# National Association of Lift Makers

18 October 1993

## **Hammond and Champness Ltd, G70 Overspeed Governor**

# GOVERNOR G.70

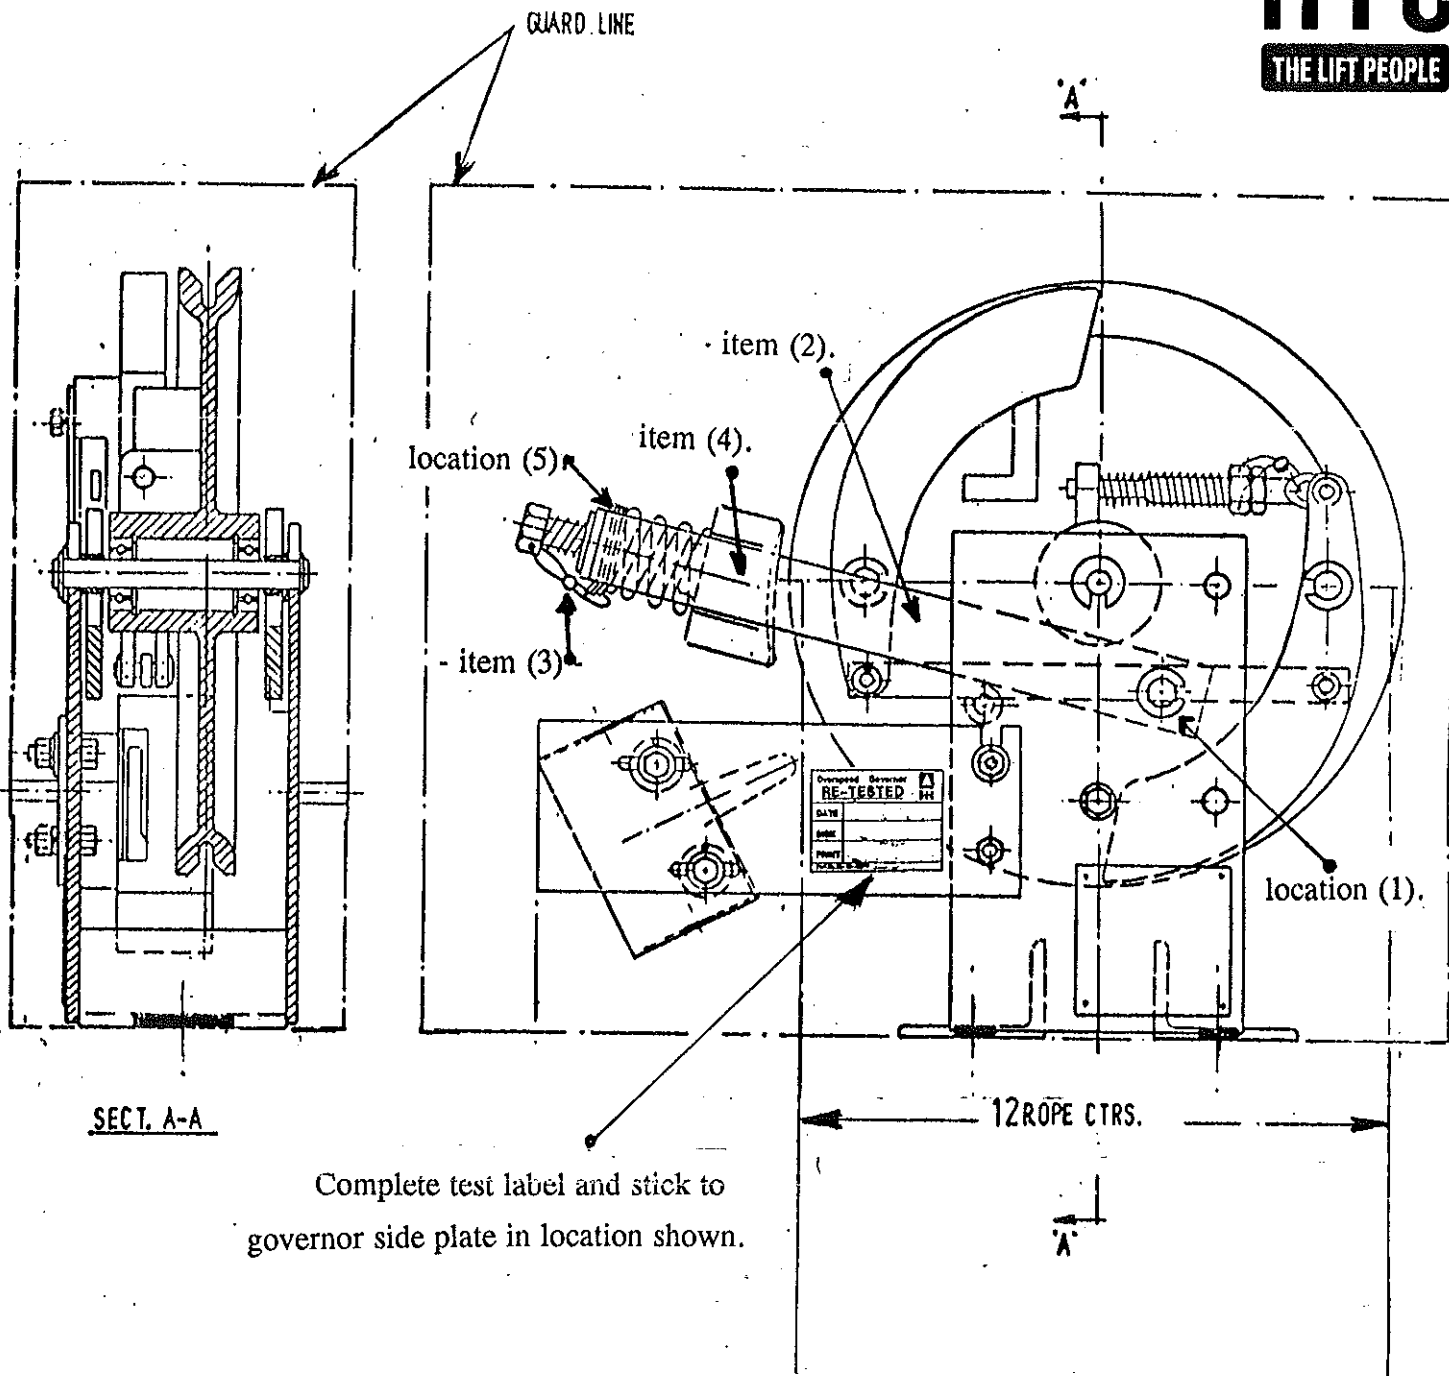
Due to a reported slight machining error on the above referenced overspeed governor rope clamping jaw, and although this does not appear to alter operational performance of the governor and its effectiveness to operate the safety gear, it is considered prudent that all existing clamping jaws be replaced.

For recognition purposes an illustration of the G70 overspeed governor is attached. Replacement jaw kits (part no 2.2041.21.01) containing fitting instructions are available from:
